Access Compliance Report

Public Rights-of-Way

Intersection ID: 3286	Main Street: MARATHON_HILL_RD	Cross Street: OLD_TIMBER_RD	Location: E
ADA ID: A86A4DBE75FC	Ramp Type: Perp	Initial Pass/Fail: Fail	Overall Compliance: No
Severity Score: 46.25			
Codes/Mitigation Info/Possible Solution		Field Measurements/Component Compliance

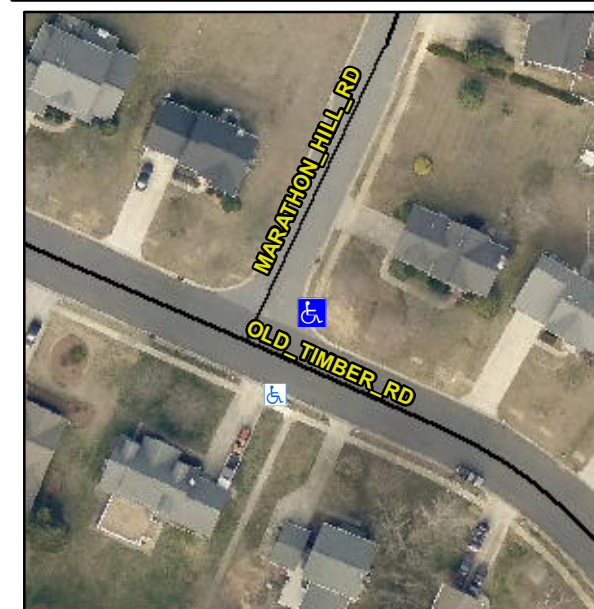
Not Found, R304.5.1, R304.2.2, R304.5.3

Compliance	Description	Data	Compliance	Description	Data
N/A	Ramp Length (in)	43.5	No	Ramp Slope (%)	8.9
No	Ramp Width (in)	41.0	No	Ramp XSlope (%)	8.0
N/A	Flare Type LT	N/A	N/A	Flare Type RT	N/A
N/A	Flare Slope LT (%)	N/A	N/A	Flare Slope RT (%)	N/A
N/A	Flare Traversable LT?	N/A	N/A	Flare Traversable RT?	N/A
N/A	Landing Length (in)	N/A	N/A	DWS Provided?	N/A
N/A	Landing Width (in)	N/A	N/A	DWS Contrast?	N/A
N/A	Landing Slope (%)	N/A	N/A	DWS Length (in)	N/A
N/A	Landing X Slope (%)	N/A	N/A	DWS Full Width?	N/A
N/A	Landing Curb? (Y/N)	N/A	N/A	DWS Offset (in)	N/A
N/A	Shared Landing?	N/A			
N/A	Gutter Ponding?	N/A	N/A	Gutter Slope (%)	N/A
N/A	Gutter Lip Ht (in)	N/A	N/A	Gutter X Slope (%)	N/A
N/A	Painted X Walk1?	No	N/A	Painted X Walk2?	N/A
	X Walk 1 Direction	To SW		X Walk 2 Direction	N/A
N/A	X Walk 1 Width (in)	N/A	N/A	X Walk 2 Width (in)	N/A
	X Walk 1 Slope (%)	2.3		X Walk 2 Slope (%)	N/A
	X Walk 1 X Slope (%)	5.9		X Walk 2 X Slope (%)	N/A

Remove & Replace Entire Ramp.
